APPLICATION FOR MODIFICATION ASSESSMENT REPORT

Application Number:	Mod2021/0362
----------------------------	--------------

Responsible Officer:	Catriona Shirley
Land to be developed (Address):	Lot 102 DP 13760, 24 Wandeen Road CLAREVILLE NSW 2107
Proposed Development:	Modification of Development Consent DA2020/1163 granted for construction of a dwelling house including a swimming pool
Zoning:	E4 Environmental Living
Development Permissible:	Yes
Existing Use Rights:	No
Consent Authority:	Northern Beaches Council
Delegation Level:	NBLPP
Land and Environment Court Action:	No
Owner:	Krystal Ann Pszczonka
Applicant:	Rise Projects Pty Ltd

Figure 1: Extent of the additional building height non-compliance shown in green.

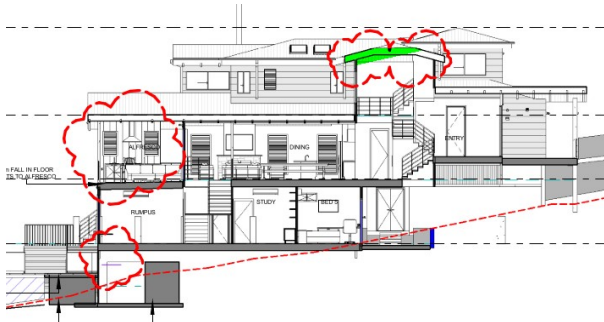
The additional building height non-compliance is demonstrated in Figure 1 & Figure 2 below.

The proposal is for a three (3) level level dwelling house, with the modified design to include an additional void area over the internal access stairs of the First Floor. It is the new void area/roof form that contributes to the additional non-compliance.

The non-compliance is located at the western edge of the roofline (demonstrated in figure 1 & 2 above) due to the topographical nature of the site.

The portions of the development that exceed the 8.5m building height plane are limited in height and depth, as demonstrated in Figure 1 and 2 above. The protrusions are reasonably described as minor.

In this case, the additional non-compliance is located at the new void area, along the western edge of the roofline and wall plane of the First Floor level. Whilst the building height variation is to a maximum of 9.1m, the overall height of the additional void area is below the existing RL43.997. The non-compliance is largely unavoidable due to the steep slope of the site, minor in size and is supported.

Figure 3: View lines from No. 22 Wandeen Road private open space area toward the window openings which are circled in red. (Source: Rise Projects)

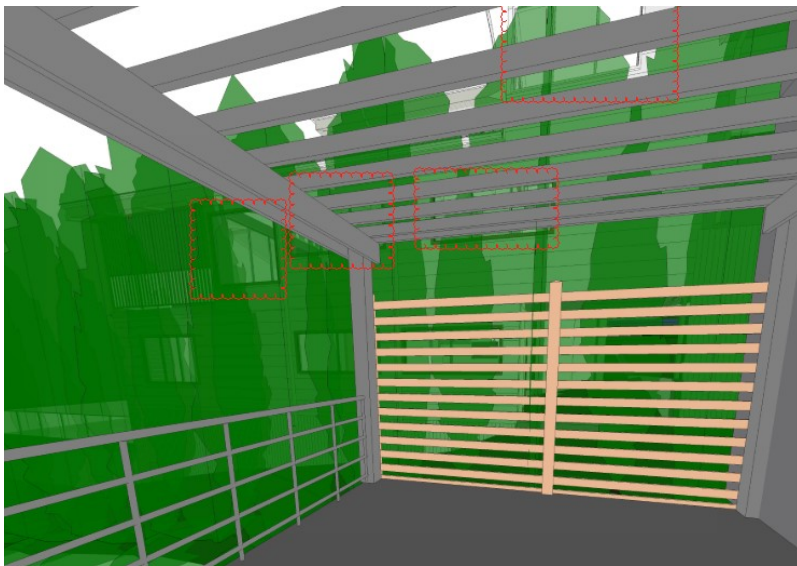
The amended development plans have made no attempt to further resolve overlooking of No. 22 Wandeen Road to the west of the existing site and the provision of clear glazing results in unacceptable privacy impacts. See Figure 3 below.

However, as there are no proposed design changes to minimise the potential privacy impacts from the western elevation window openings, there are no grounds to change the assessment and determination in relation to privacy impacts.

As a result, the previous condition applied by the NBLPP (condition 8) will be retained on the consent and modified to include the additional First Floor window on the western elevation.

Figure 6: Extent of additional building envelope non-compliance on the western elevation shown in green.

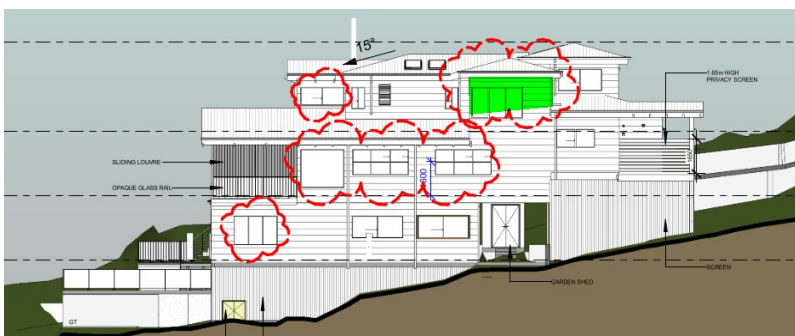
- West Elevation: up to 0.8m (height) and 1.9m (width).

The figure below shows the location and extent of the non-compliance.

As stated within the control "where the building footprint is situated on a slope over 16.7 degrees (ie; 30%), variation to this control will be considered on a merits basis".

The facade of the dwelling on the west elevation is sufficiently modulated to respond aspect of the site and its steep slope. The resultant amended development is considered to be a sensitive design response in consideration of the natural characteristics of the site, with the retention of existing canopy trees and the enhancement of landscaping.
